FMTV...

Get Upgraded M777 Howitzer Latch Kit

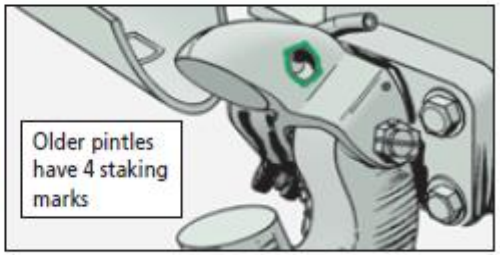
But chances that this separation could happen are increasing with older versions of the M1083 or M1093 pintle hooks that use a staked latch pin assembly. You can identify these old-style pintles by the four staking marks on each side of the latch pin. They make sure the pins stay in the latch assembly.

Prevent separation while towing by getting the upgraded pintle latch kit. This new RK-775 latch kit, NSN 2540-01-579-6710, replaces the upper pintle hook latch assembly with a non-staked, positive retention assembly.
